# ADJUSTMENTS TO ENVIRONMENTAL IMPACT ASSESSMENT

## – HEJRE TIE-BACK TO SOUTH ARNE

### Appendix 1

Doc. no. HEA-GEN-SA-REP-0016  
Rev. no. 2

Figure 2-1 Pipeline and power cable route from Hejre to South Arne

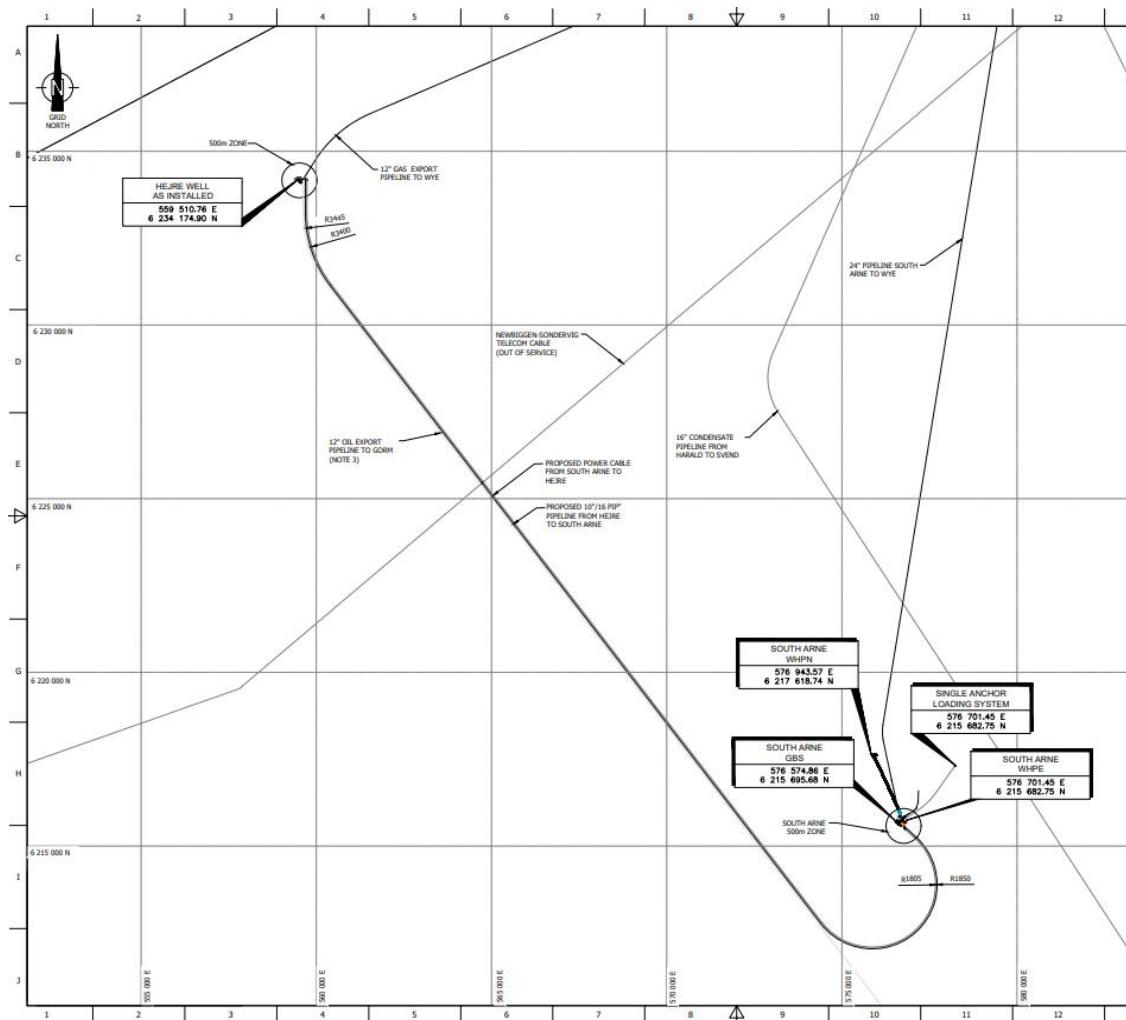
- The optional well Lunde will not be drilled. This means that there will be only 3 instead of 4 wells in production. The scope has thus been removed from Hejre EIA. The associated impact has been reduced accordingly.
- Pipeline and cable have been slightly relocated. This is done to place them with in the safety zone of the existing 12" pipeline to the Gorm platform. The two pipelines will be parallel to each other and there will be no crossings. This means that no route survey and no seismic survey is needed since data from the trenching of the existing pipeline can be used instead. Due to this, the pipeline and cable will be 33 km instead of 30 km long. The updated additional protection zone is reduced from 11.2 to 2.4 km<sup>2</sup>, due to the placement next to a pipeline in an existing protection zone. The new pipeline route is as shown in Figure 2-1.

Figure 2-2 High-level time schedule for the Hejre field re-development. Abbreviations: D&C: Drilling and completion, EPC: Engineering, Procurement, Construction, T&I: Transport and Installation, HUC: Hook-Up and Commissioning.

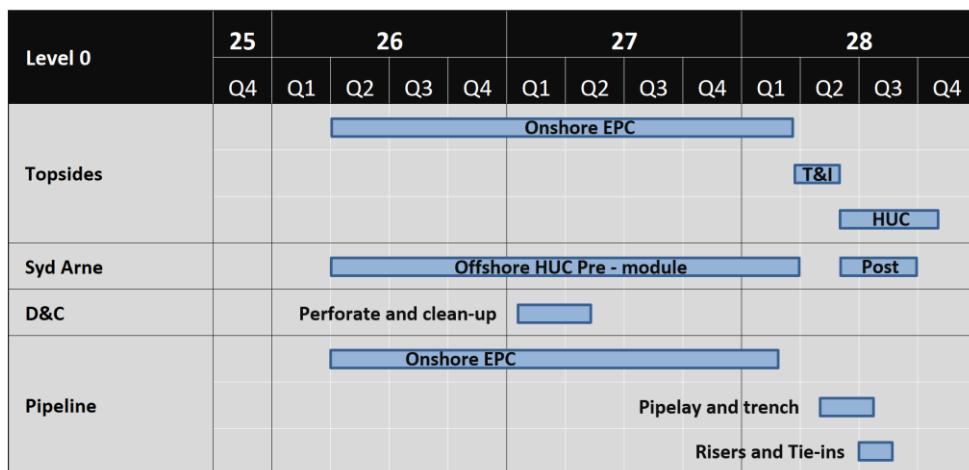
- There are adjustments in the time schedule due to the decision from the Energy Board of Appeal, the new timeline is seen in Figure 2-2. The main changes are:
  - Movement of Topsides offshore activities (transportation, installation and hook-up) from 2027 to 2028.
  - Movement of the pipeline offshore installation activities from 2026 to 2028.
  - Movement of the offshore drilling scope (perforation and clean-up) from Q3 and Q4 2027 to Q1 and Q2 2027.

These changes move first oil from Q4 2027 to Q4 2028.

Figure 6-18. Distribution of historical catches of European Sturgeon in Danish Waters. Copied from Møller & Carl, 2019).

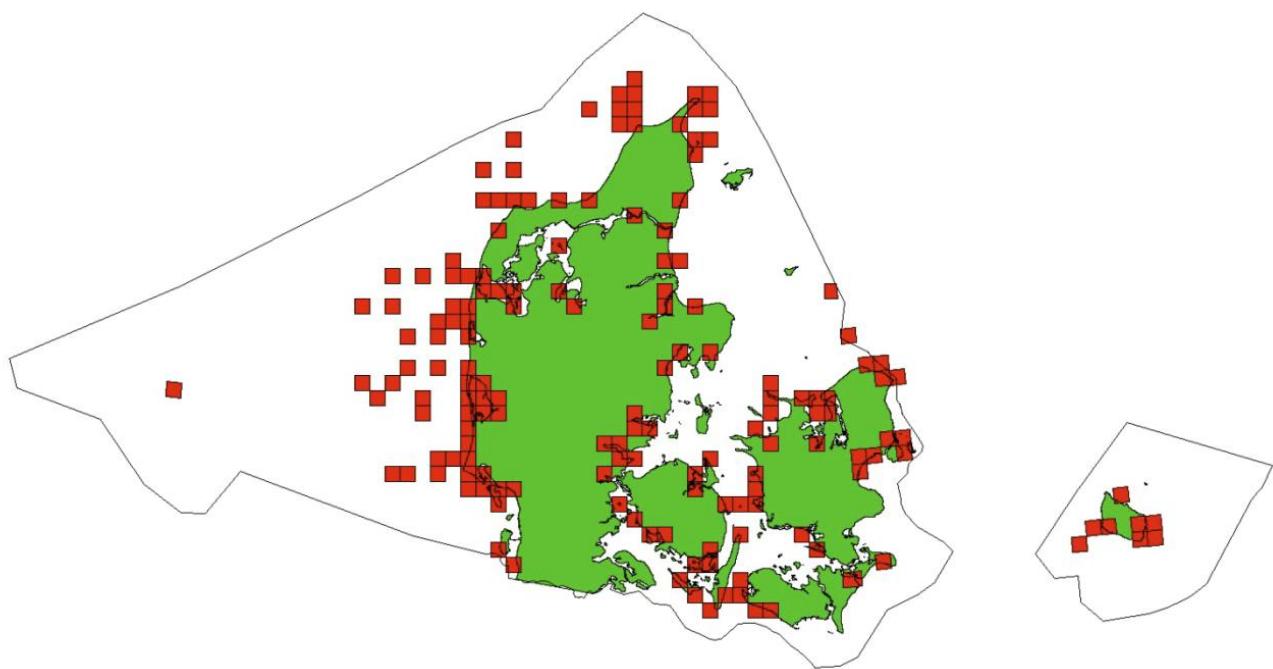
The section on fish has been updated to include the Annex IV species sturgeon. A new section, 6.6.5 has been added.

The historical catch records show occurrences across most regions (Figure 6-18), with the highest catch numbers found along the coastal areas of the North Sea and Skagerrak (Møller & Carl, 2019).

Figure 9-1 Overview of impacts during the production phase assessed in the EIA.

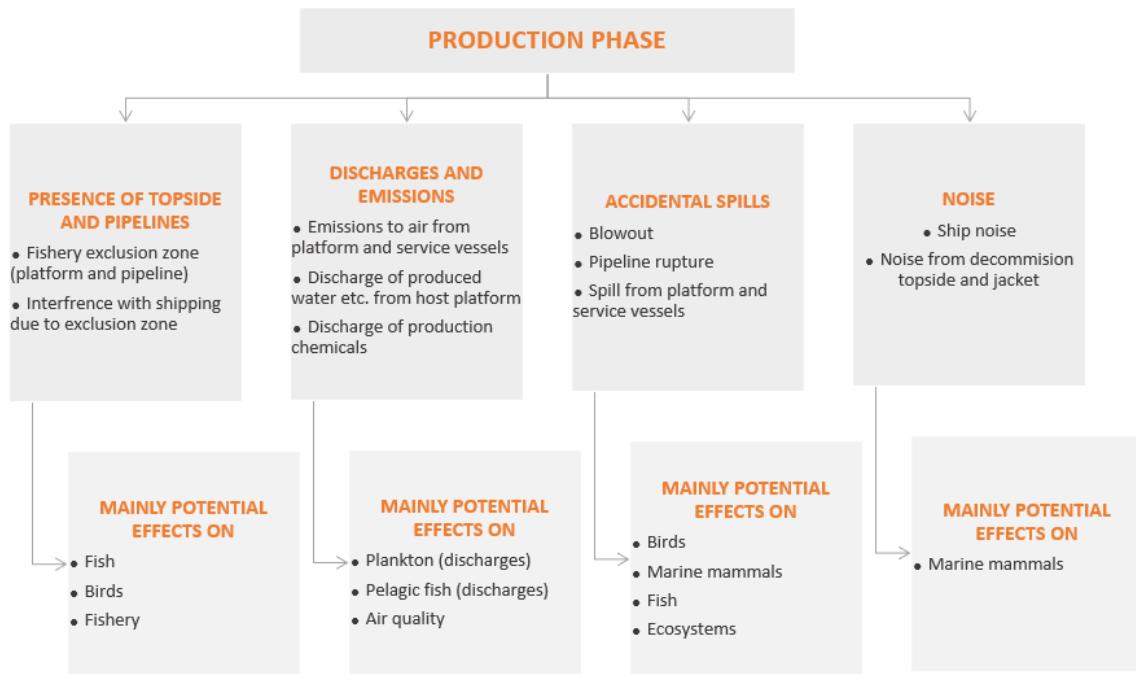
The impact overview diagram and table have been updated to include underwater noise from surveys and maintenance during the production phase:
